SS 1033364 - New Cascadia Forward Chassis Harness Chafe

Inspection / Correction Process for New Cascadia (P4) Forward Harness Chafing

05-33754-000

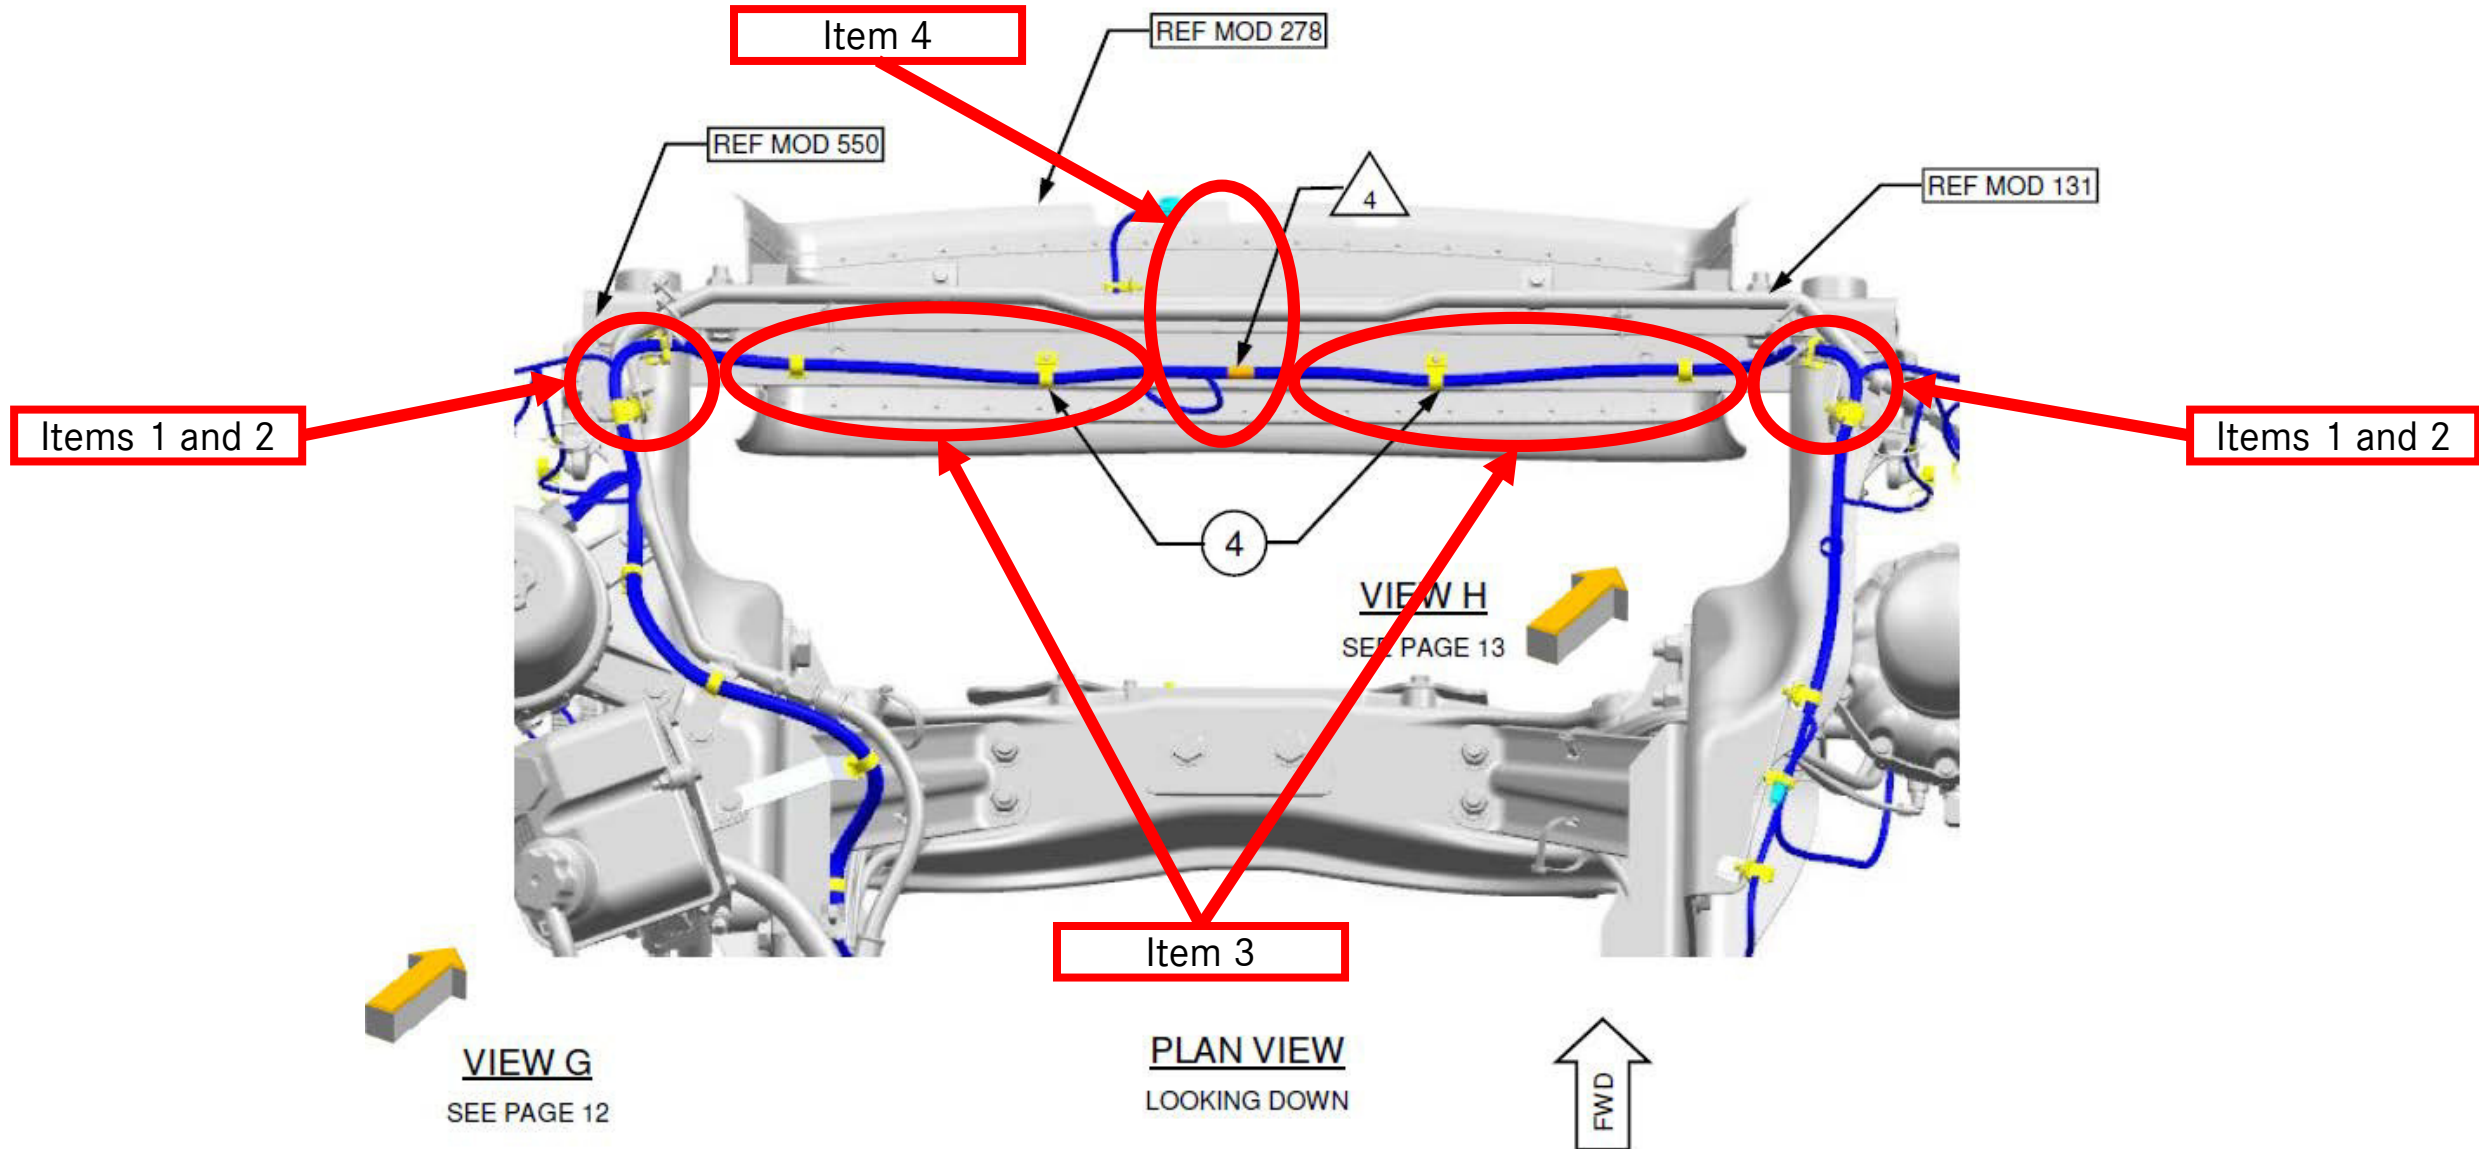
Need to trim 25mm
Off each bottom end
Of the recirculation
Baffles.

Items 1 and 2 (Driver side shown, Passenger side similar)

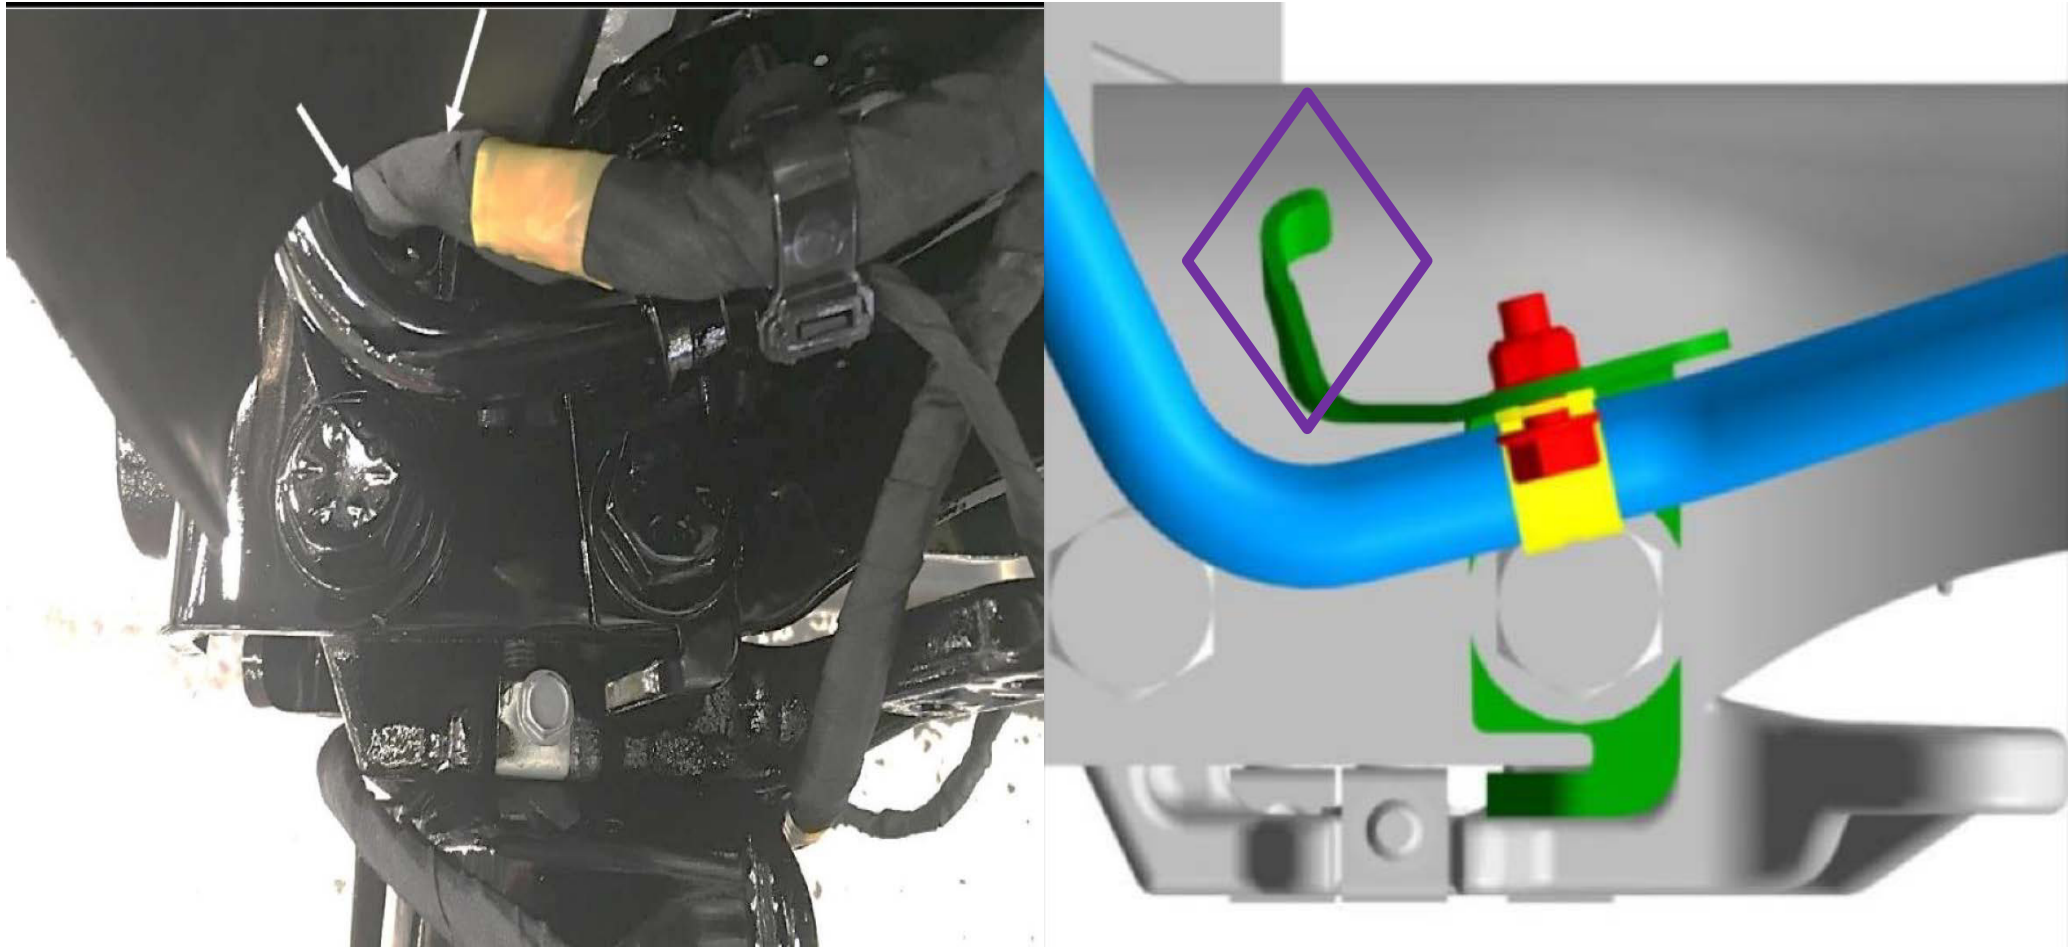
Radiator baffle pictured below is before trimming (white arrows show chafe points). Trim baffle. Bend the purple diamond area of the green bracket (for both the driver and passenger sides of the vehicle), so it is parallel to the closing cross member. This will help separate the harness from rubbing on the tube at this junction. Inspect the entire area, adding butterfly tie straps (p/n TYC DCT110HIR) between the harness and tube as needed to maintain separation, and to prevent rubbing on the bracket.

Item 3

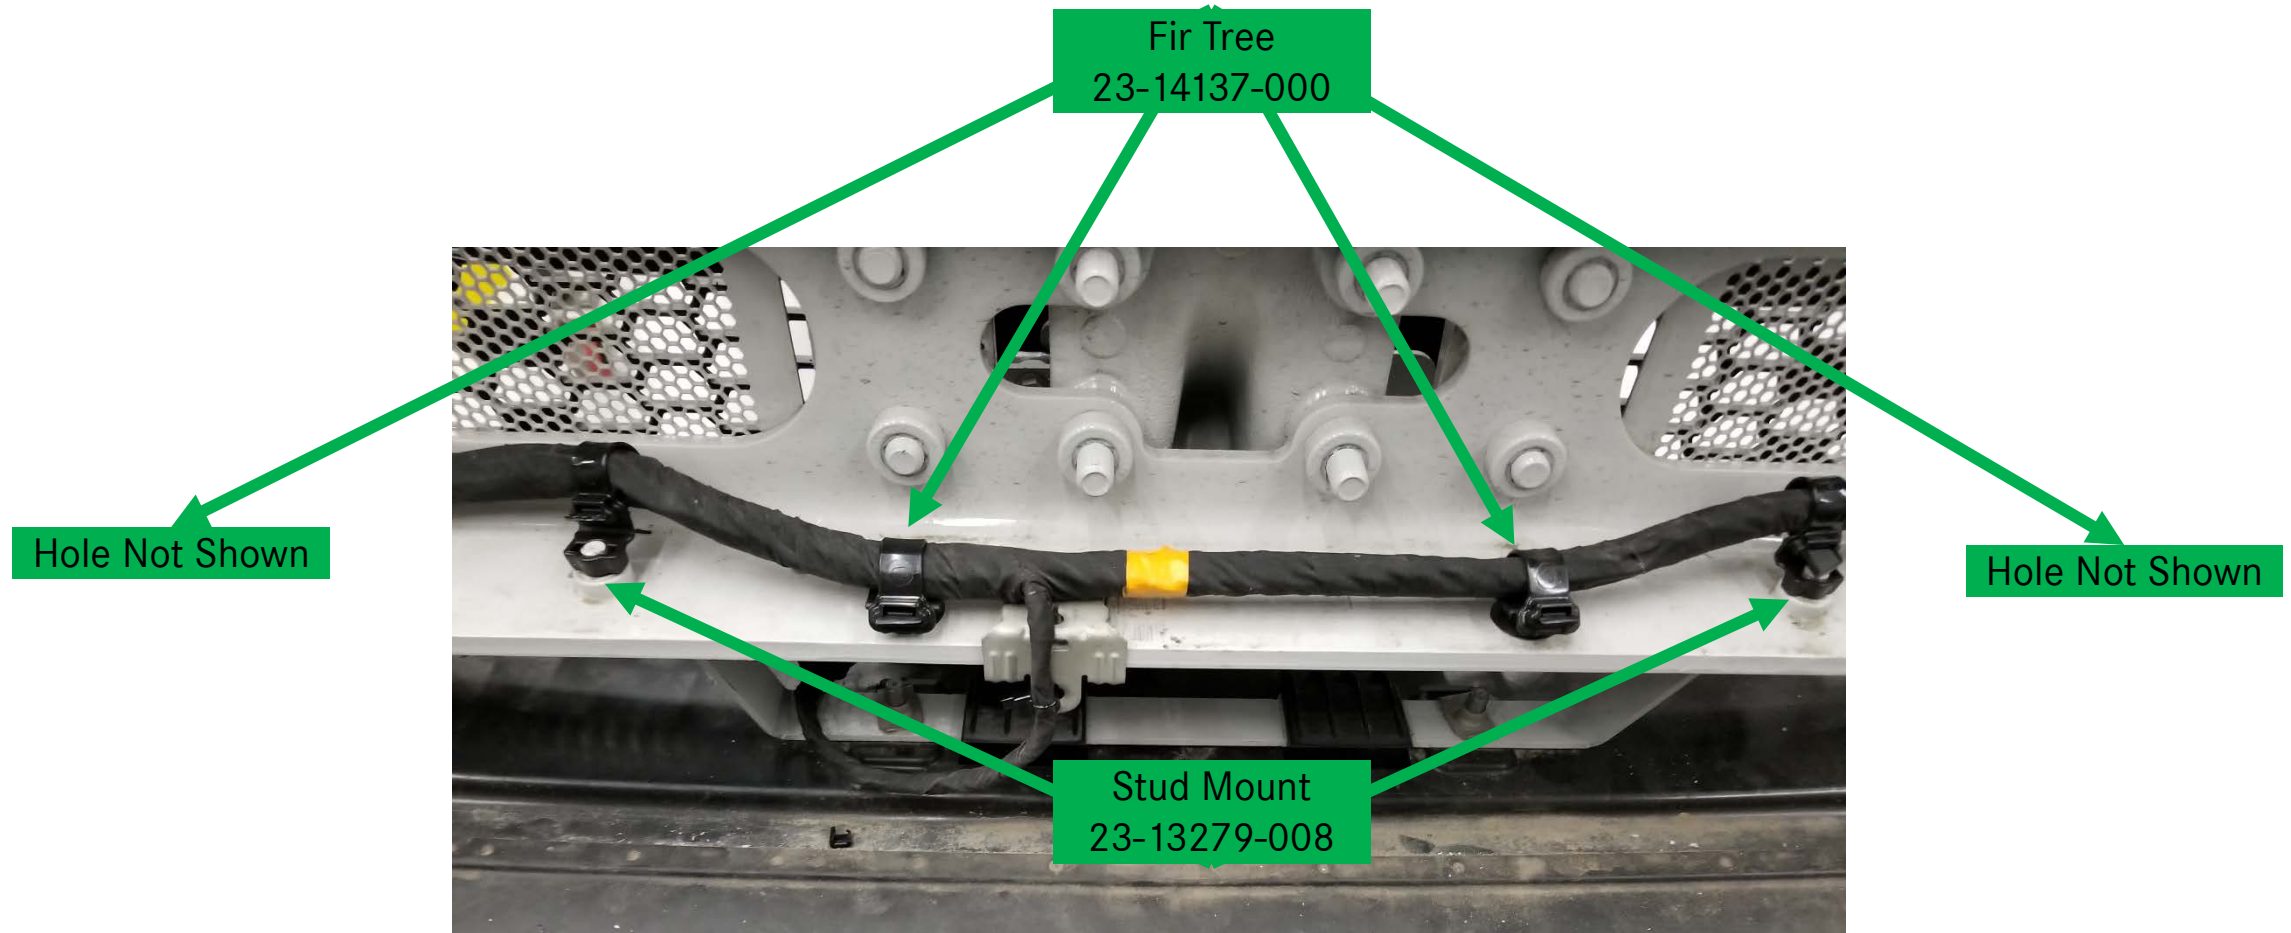
Bad Cross Member Harness Routing (could result in wiring and cooler failure)

Inspect the forward harness routed inside the closing cross member for any potential chafe points. Ensure the main harness is securely fastened to the cross member as shown, to maintain separation between it and any other components.

Closing cross member harness attachment points

Item 4 Forward radar harness

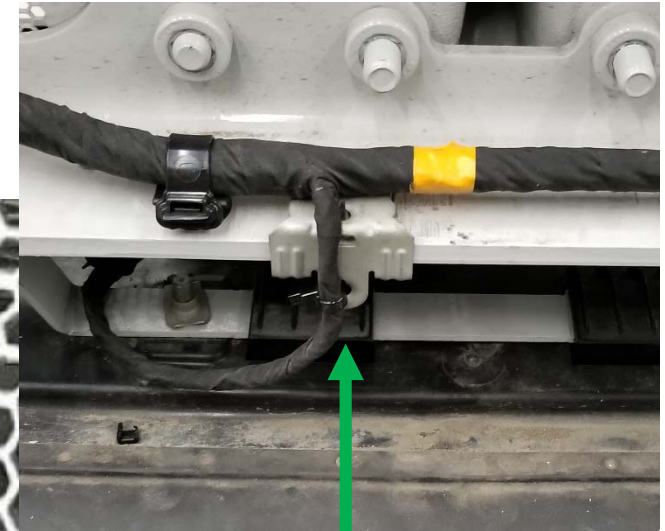
If equipped with forward radar, inspect the break-out where it leaves the main harness. Add a caddy clamp and tie strap to prevent chafing on the cross member. Also add an edge clip at the rock guard to prevent rubbing.

Edge Clip
23-13477-100

Caddy Clamp
A 681 997 08 90
Tie Strap
23-09796-309
